SERVICE BULLETIN

#0022

SUBJECT: Replacement of improperly de-embrittled bolts

Figure 1: Sling 2 engine mount to engine frame attachment

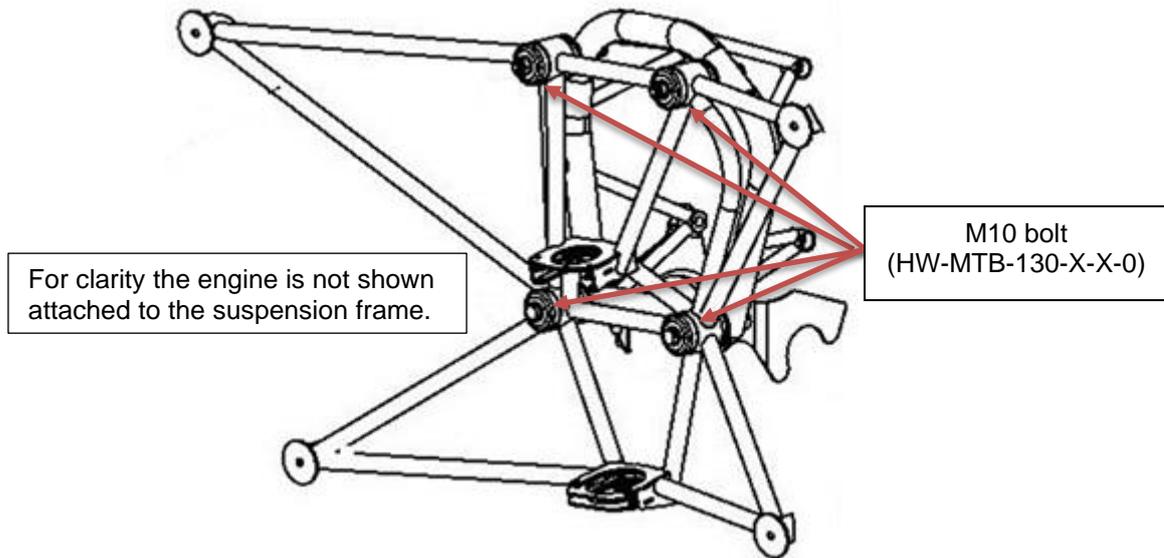
- Step 1: Before any bolts can be replaced, the aircraft's cowling needs to be removed. To do so, refer to the Sling 2 & Sling LSA Maintenance manual (DC-MAM-002-X-B) Section 5.1.1.
- Step 2: The four M10 bolts (HW-MTB-130-X-X-0) that mount the engine to the engine frame need to be replaced. These bolts can be seen in the exploded view of the engine mount in Figure 1.

Figure 3: Bolt replacement sequence

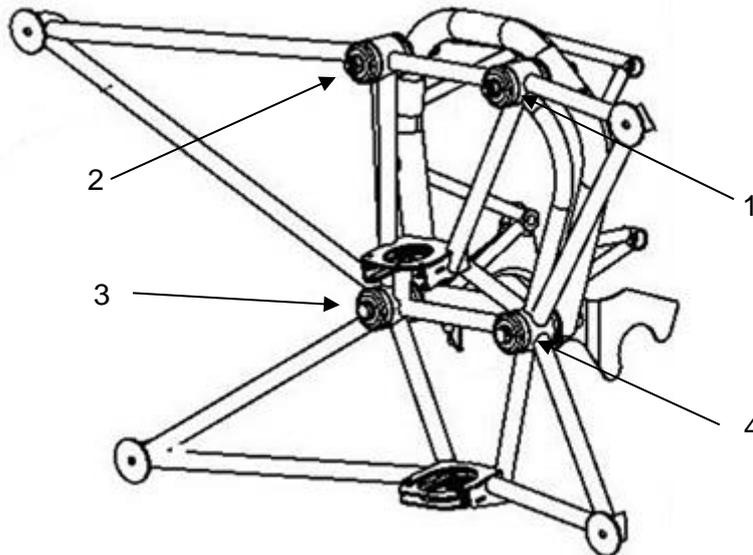
Step 4: Once the engine is supported, the bolts can be replaced *one by one*. Refer to Figure 3 and replace the bolts in order. Remove bolt 1 and install a new bolt. Torque the bolt to 38 Nm. Ensure all washers, rubber stoppers and spacers are installed in the correct positions when replacing the bolts. Once bolt 1 has been replaced and torqued to 38 Nm, replace bolt 2, which should then also be torqued to 38 Nm.

Figure 6: M8 bolts connecting the propeller extension and engine flange

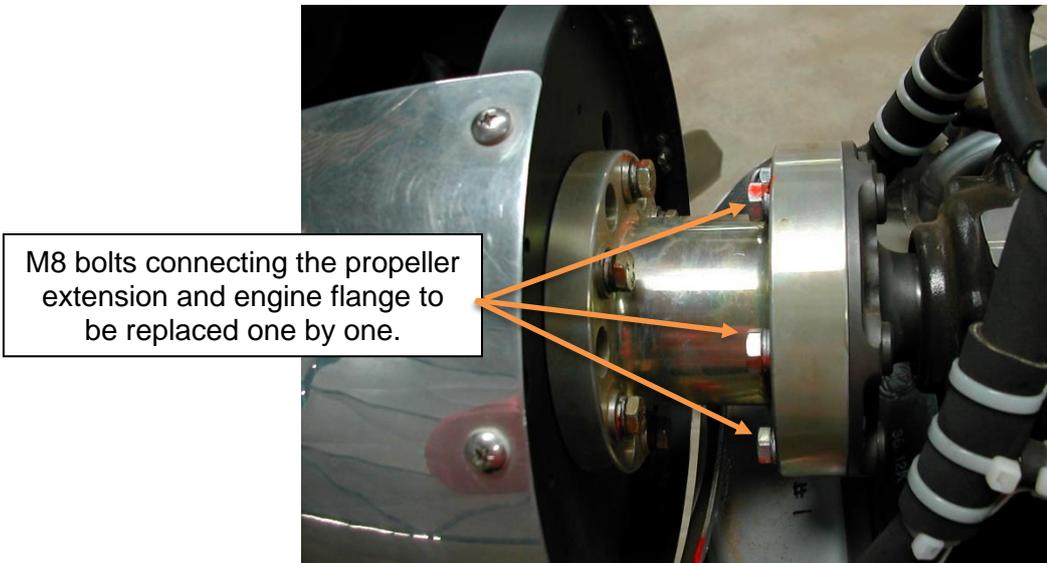
- Step 1: Before any bolts can be replaced, the aircraft's cowling needs to be removed. To do so, refer to the Sling 2 & Sling LSA Maintenance Manual (DC-MAM-002-X-B) Section 5.1.1.
- Step 2: It is possible to replace the M8 bolts (HW-MTB-840-X-X-0) without removing the propeller.
- Step 3: The bolts that need to be replaced are the M8 bolts connecting the propeller extension and engine flange. Refer to Figure 6.

Figure 7: Propeller extension bolt replacement sequence

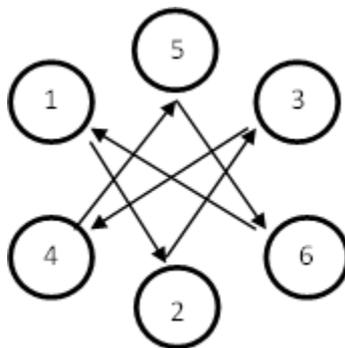
- Step 4: Support the propeller and replace the M8 bolts one by one. This will allow the propeller to remain attached during the replacement process. The bolts should be replaced in accordance with the sequence shown in Figure 7. Loctite 243 should be applied to the threaded section of each replacement bolt before it is installed. Ensure that only one bolt is replaced at a time, and it gets torqued to the correct torque value of 24 Nm, before the next bolt is replaced.

Figure 8: Sling 4 TSi engine mount to engine frame attachment

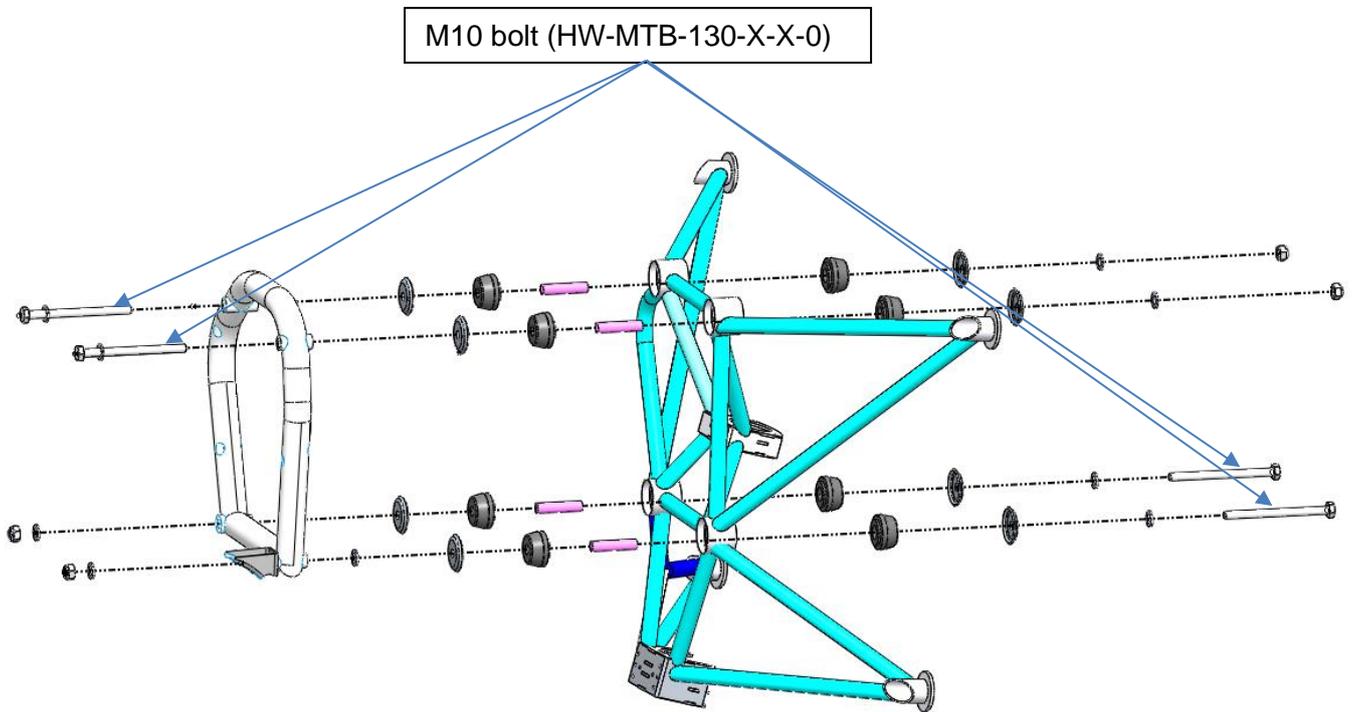
- Step 1: Before any bolts can be replaced, the aircraft's cowling needs to be removed. To do so, refer to the Sling 4 TSi Maintenance Manual (DC-MAM-001-X-F) Section 5.1.1.
- Step 2: The four M10 bolts (HW-MTB-130-X-X-0) that mount the engine to the engine frame need to be replaced. These bolts can be seen in the exploded view of the engine mount in Figure 8.

Figure 10: Bolt replacement sequence

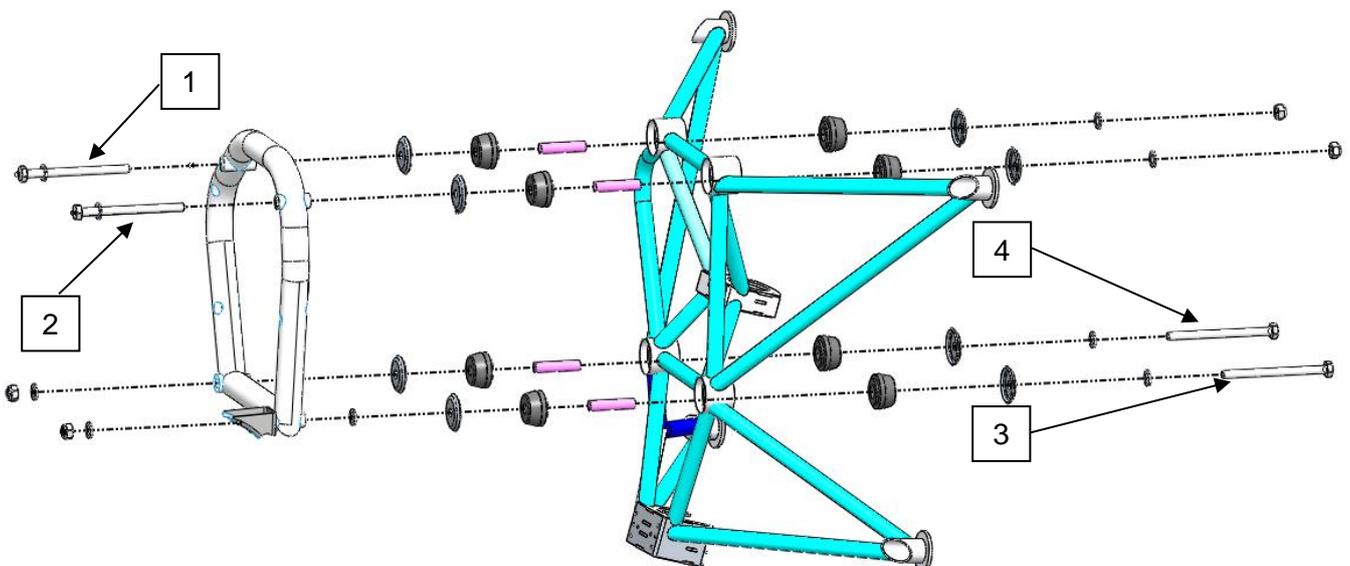
Step 4: Once the engine is supported, the bolts can be replaced *one by one*. Refer to Figure 10 and replace the bolts in order. Remove bolt 1 and install the new replacement bolt. Torque the bolt to 38 Nm. Once bolt 1 has been replaced and torqued to 38 Nm, replace bolt 2. Repeat this process until all 4 bolts have been replaced. All bolts should be torqued to 38 Nm. Ensure all washers, rubber stoppers and spacers are installed in the correct positions when replacing the bolts, as seen in Figure 10. The muffler of the Sling 4 TSi does not need to be lowered in order to replace the M 10 bolts shown in Figure 10.
